CONTRACT CHANGE ORDER NO. ____
SHEET ____ OF ____

MARK	DATE	DESCRIPTIONS	BY	CH'D	CCO#
2	12/10/10	MISCELLANEOUS ELEVATOR DETAILS	JNB	FS	174
1	07/17/09	ELEVATOR DETAILS	JNB	FS	85

ELEVATOR DETAIL NO. 1

SAN FRANCISCO OAKLAND BAY BRIDGE
EAST SPAN SEISMIC SAFETY PROJECT
SELF-ANCHORED SUSPENSION BRIDGE
(SUPERSTRUCTURE & TOWER)

TOWER SHAFT DETAILS NO. 8

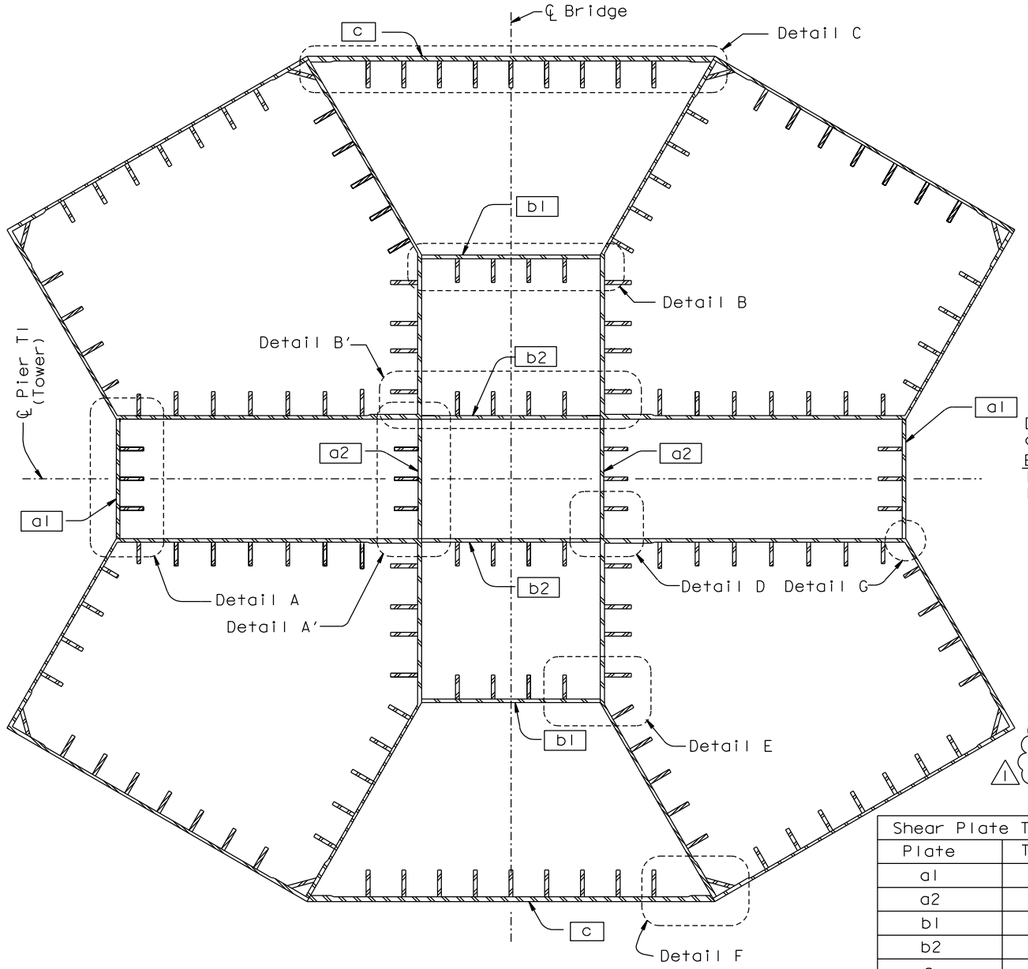
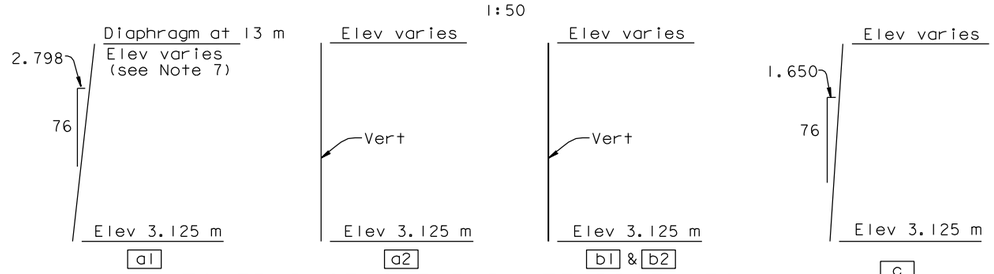
8. Access openings in tower base shear plate [c] shall be on East side of tower only.
9. At the Contractor's option, temporary access openings may be provided at locations shown in shear plates [a1] only. The openings shall be closed with fill plates which shall be identical to the respective shear plate. The fill plates shall be CJP welded all around. △1

TOWER ACCESS DETAILS NO. 25

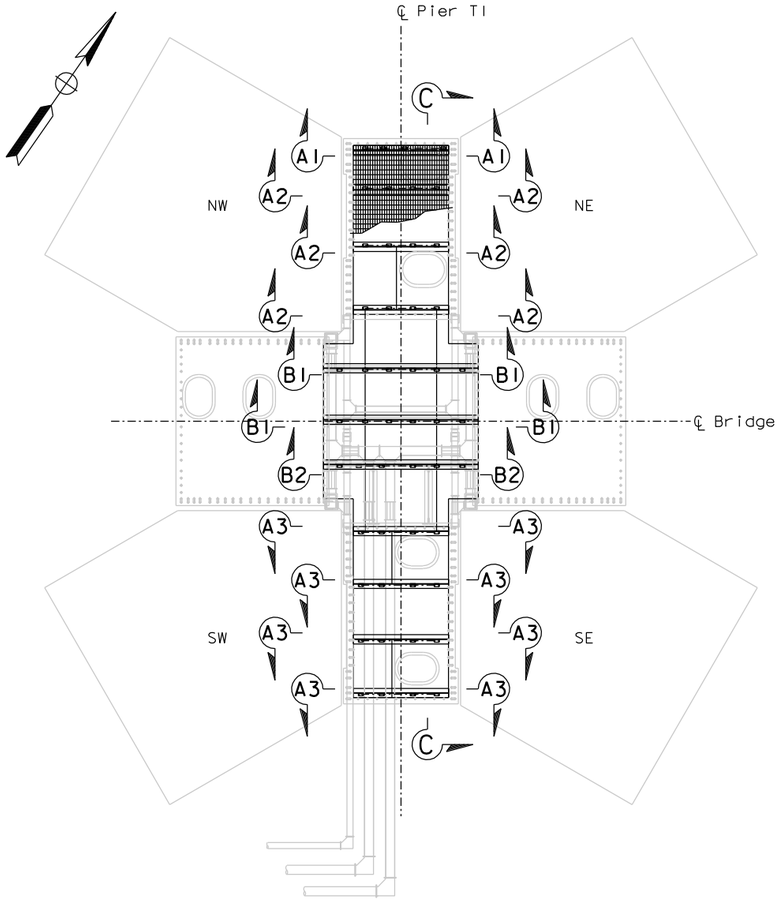
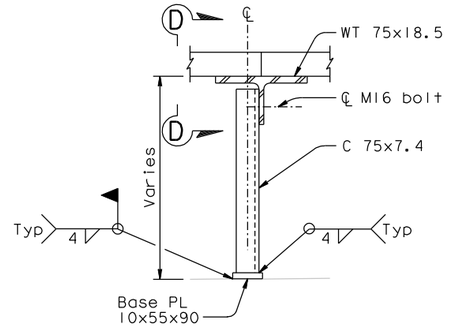
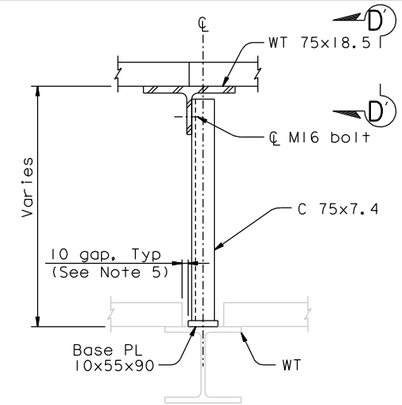
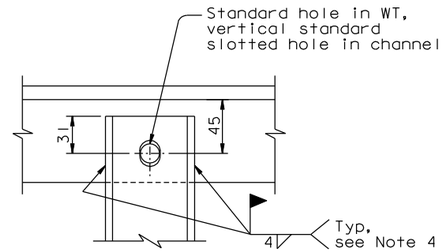
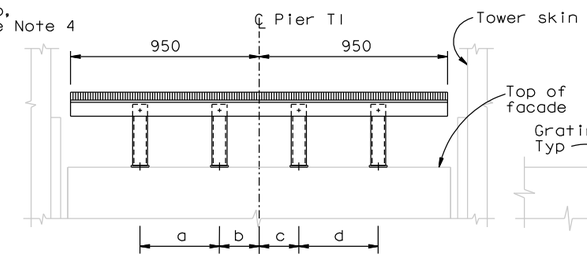
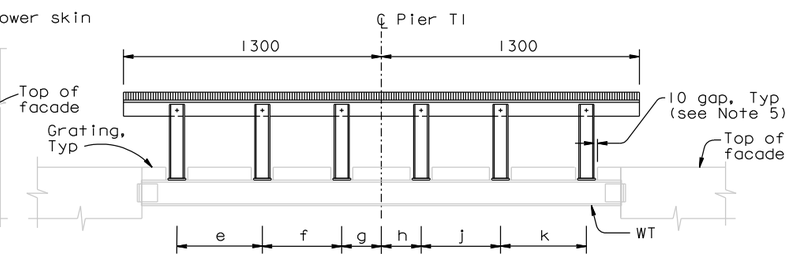
1. The Contractor shall provide fiberglass grating with fasteners. The grating shall be rated to support 5 kN/m2 loading with deflection not greater than 1 mm.
2. The top of the grating shall be level.
3. For Removable Gratings Plan, see "Tower Access Details No.26" and "Tower Access Details No.27" sheets.
4. Welding of channel to WT shall be performed after top of WT is level.
5. Cut grating to provide clearance for grating support posts.

TOWER ACCESS DETAILS NO. 26

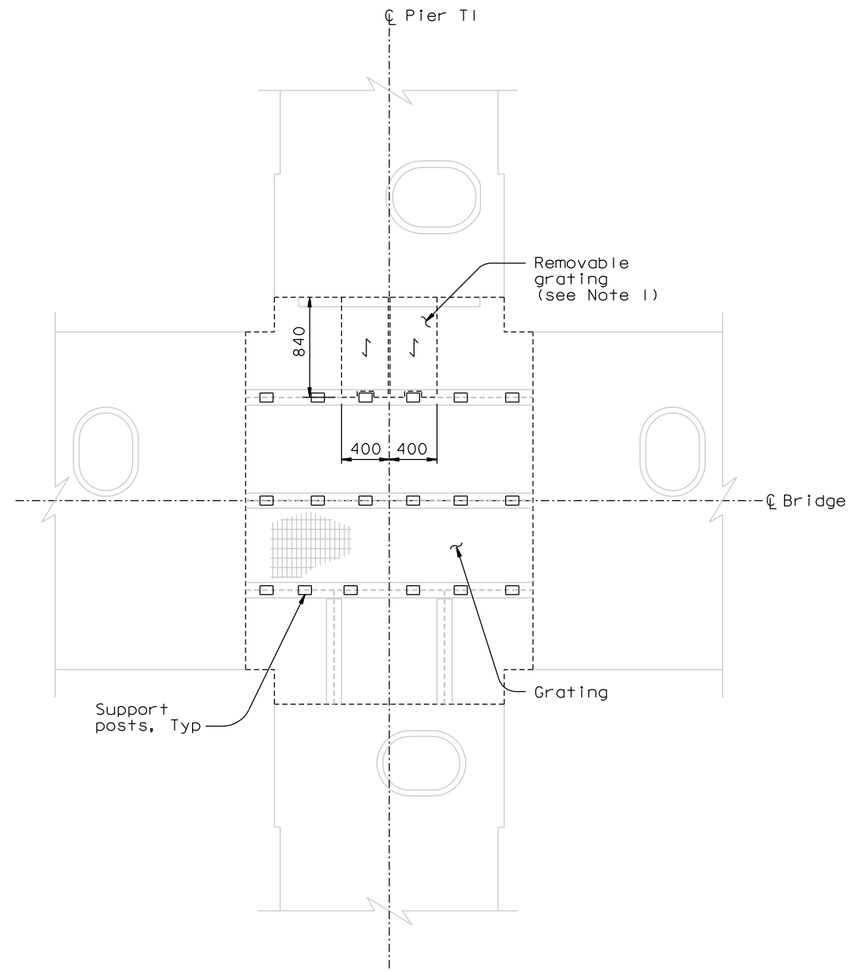
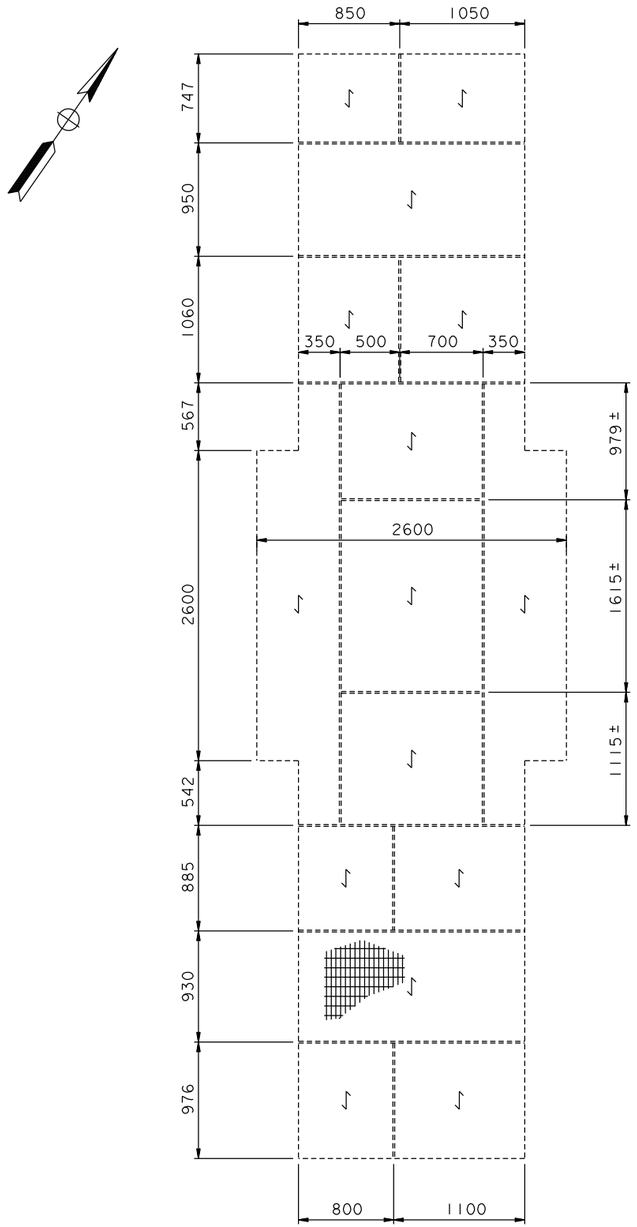
1. Modify the grating to create a removable panel at indicated location.

TOWER ACCESS DETAILS NO. 27

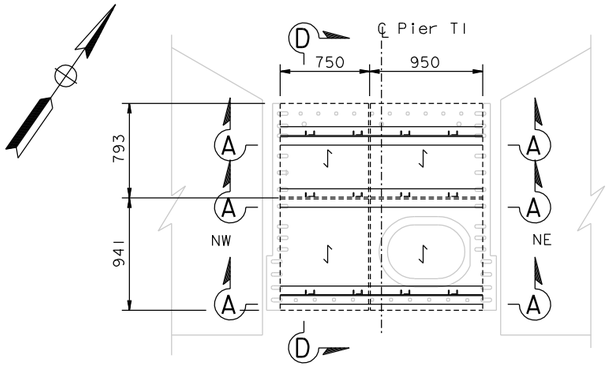
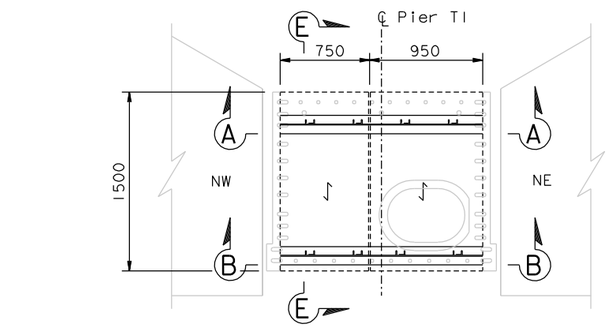
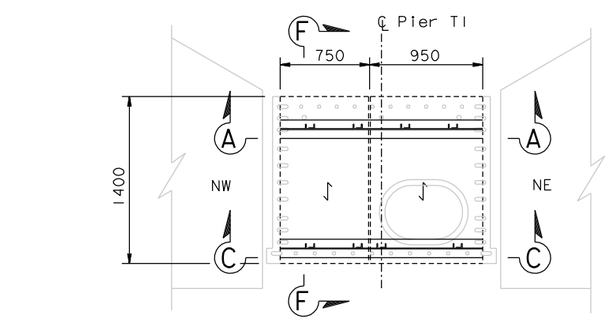
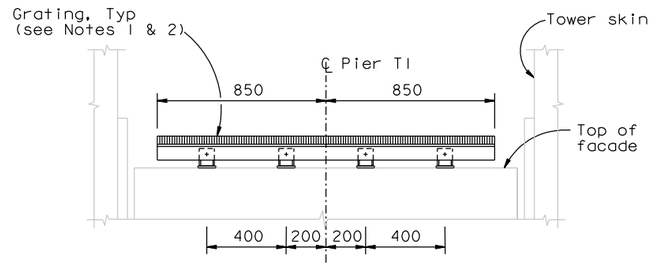
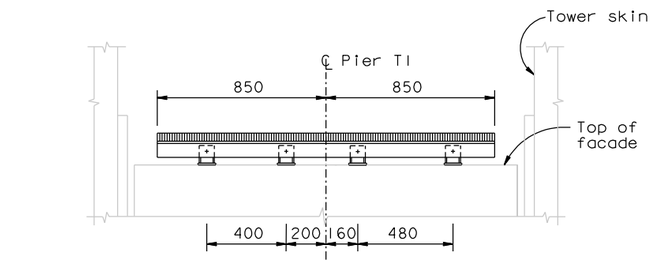
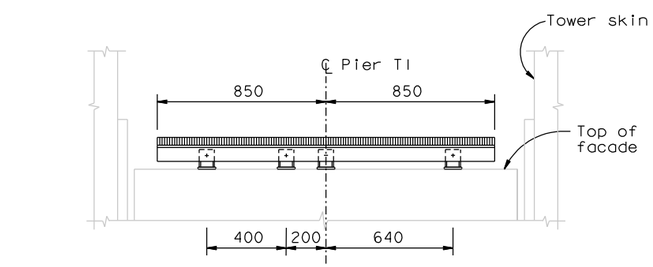
1. The Contractor shall provide fiberglass grating with fasteners. The grating shall be rated to support 5 kN/m2 loading with deflection not greater than 1 mm.
2. The top of the grating shall be level.
3. Welding of channel to WT shall be performed after top of WT is level.
